Re: EPA Review of the Proposed Title V Permit for ExxonMobil (Facility ID 80089)

RE: Preliminary EPA Comments on the Proposed Title V Permit for ExxonMobil

PRELIMINARY EPA COMMENTS ExxonMobil (Facility ID 800089) SCAQMD Proposed Permit

Attachment 2:

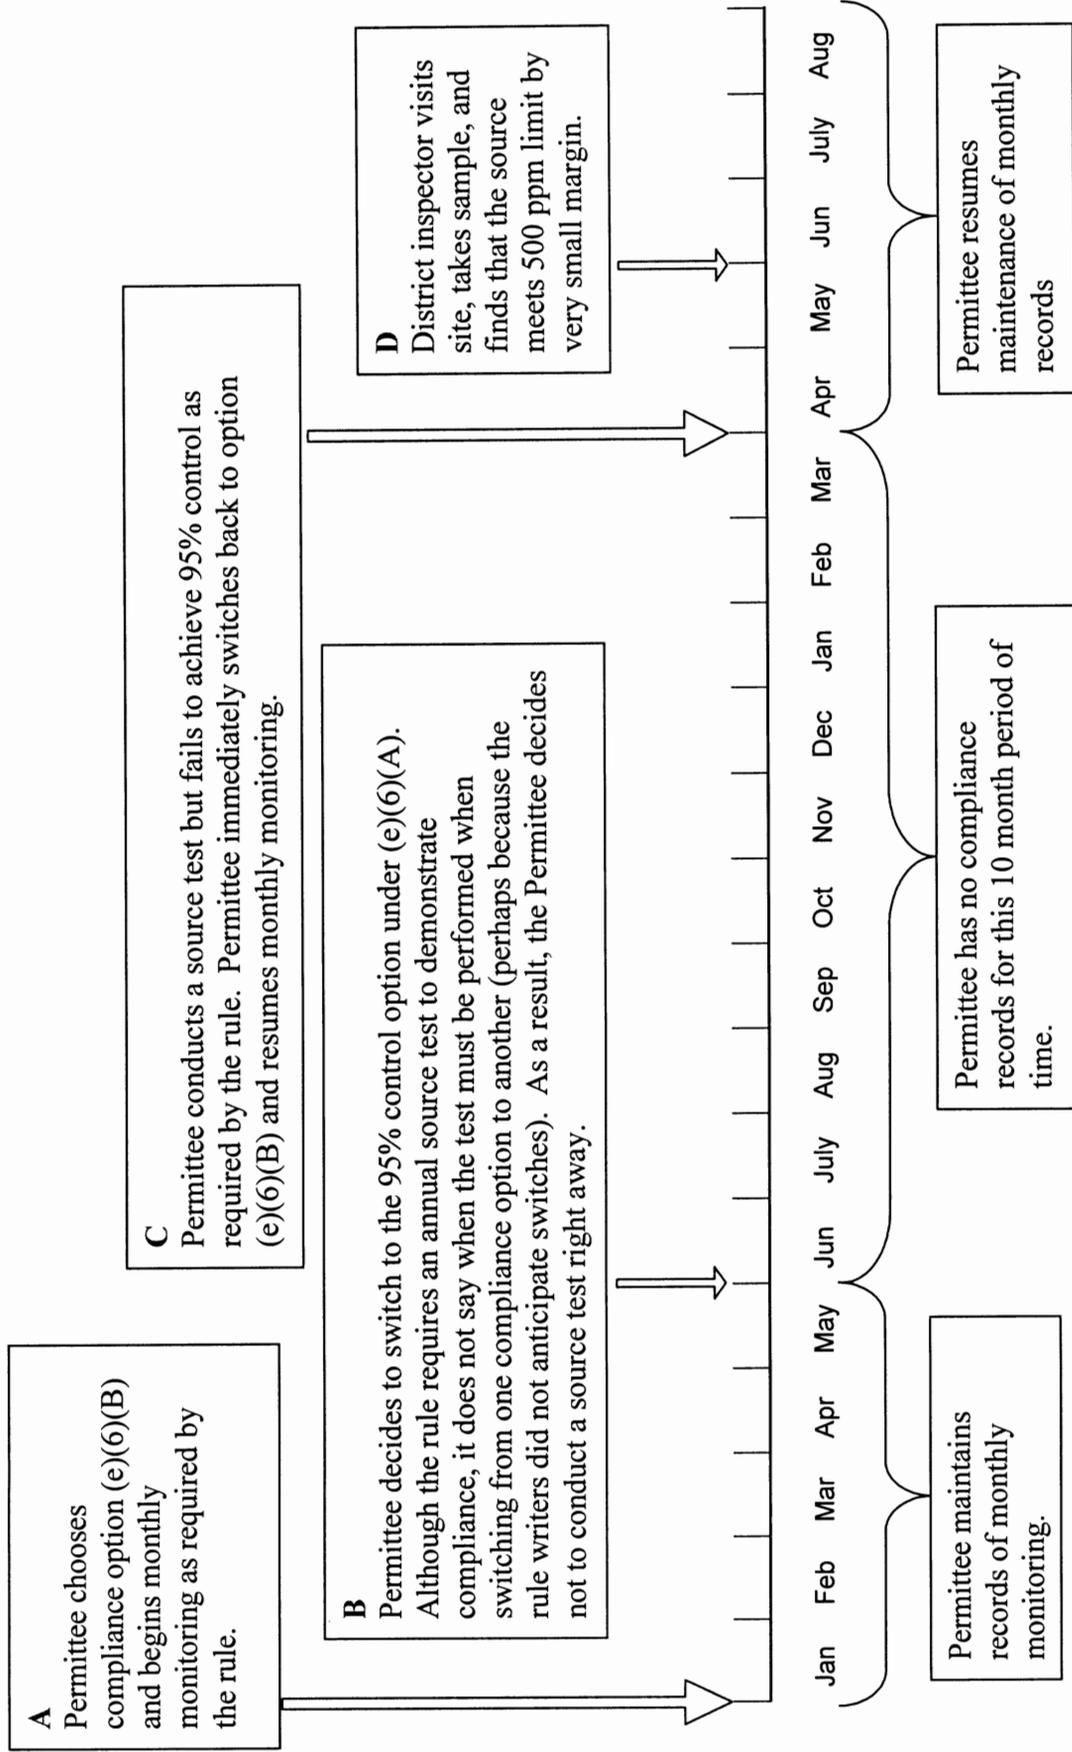
Potential Compliance Problems Arising From Lack of Detail in Proposed Title V Permit With Respect to Rule 1176(e)(6)

The problem arises in this situation because although the rule requires an annual source test to demonstrate compliance with the 95% control requirement, it does not say when the source test must be conducted in the event the Permittee switches from one option to another. The Permittee's failure to conduct the test immediately upon the change in operation and its subsequent switch back to the

The combination of the District's interpretation of the rule, the language of the rule itself, and the lack of detail in the permit fails to establish a clear compliance obligation for the source and could lead to a variety of situations like the one described above. While the District is entitled to its own interpretation of the rule, the District has an obligation to issue a permit that assures compliance with all applicable requirements. As it is currently written, the permit fails to do so with respect to the control requirements of Rule 1176(e)(6).

Air Pollution Control devices used as a means for complying with Rule 1176(e)(2) shall meet either of the requirements in subparagraphs 1176(e)(6)(A) or 1176(e)(6)(B). Contemporaneously with making a change from one method of compliance to another, the Permittee shall record in a log at the facility a record of the scenario under which it is operating. At all times, the Permittee must maintain source test results or monthly monitoring records, as appropriate, that demonstrate compliance with the chosen option.
